**TECHNICAL BULLETIN**  
**Bell Helicopter** **TEXTRON**

No. 407-03-51

**MODEL AFFECTED:** 407

**SUBJECT:** HUB FRAHM ASSY 407-010-150-ALL REMOVAL OF

Figure 1. Aircraft configuration without FRAHM assembly

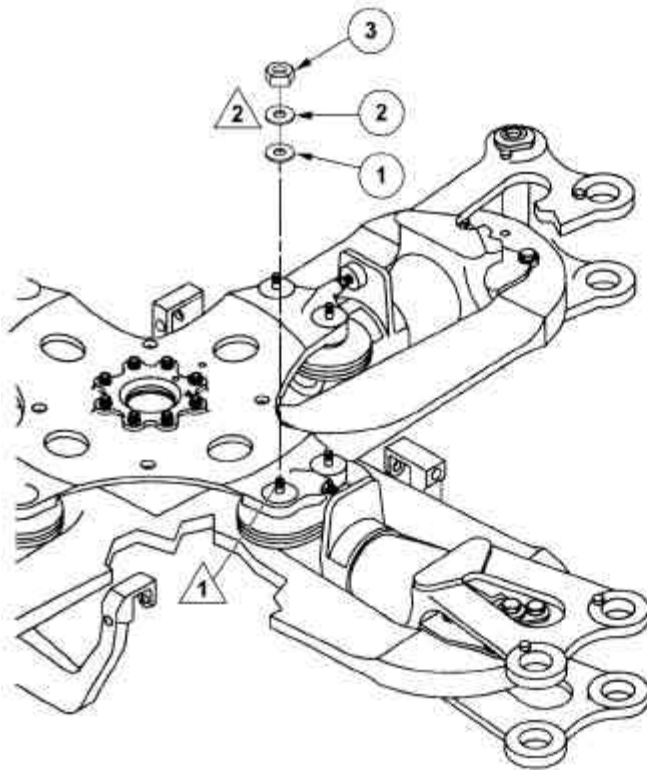
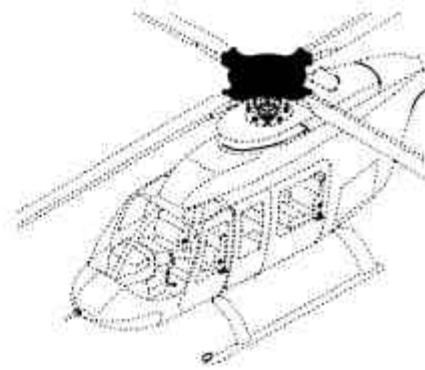
3. Apply a layer of corrosion preventive compound (C-104, BHT-ALL-SPM) to the exposed upper stud shank of the lead and lag dampers.
4. Install washers (1 and 2, Figure 1) and nuts (3) on the upper studs of the lead and lag dampers. 
5. Apply a layer of corrosion preventive compound (C-101, BHT-ALL-SPM) to the nut (3) washers (1 and 2) and exposed threads.
6. If required, adjust ballast as necessary to return helicopter weight empty CG to within allowable limits.
7. Make an entry in the helicopter Historical Service Records to show that this Technical Bulletin is completed.

- 1. Washer (140-007-24S20A8)
- 2. Washer (NAS1149F0563P)
- 3. Nut (MS21042L5)

**T** 75 to 95 IN-LBS (8.4 to 10.7 Nm)

- 1. (C-104) to stud shank. Do not apply to threads.
- 2. (C-101) to washers, nut and exposed threads.
